## CITY OF CLOVIS MEDIAN ISLAND CURB DETAILS (NEW AC PAVEMENT)

ST-25

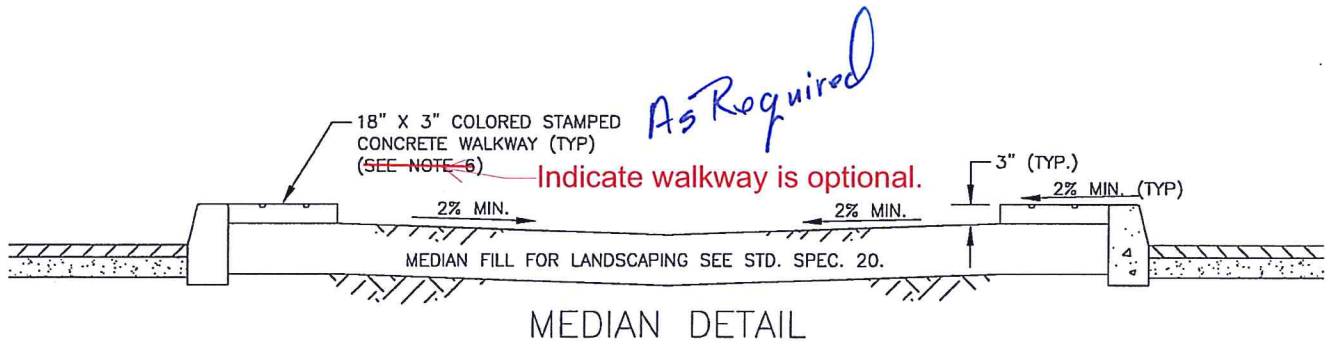
Remove reference to Note 6

Add "colored stamped" to concrete description.

Indicate walkway is optional.

Clear Seal 400 is not VOC compliant in the Valley. The Clear Seal 100 has a lower VOC content and is compliant.

Remove Note 6

100
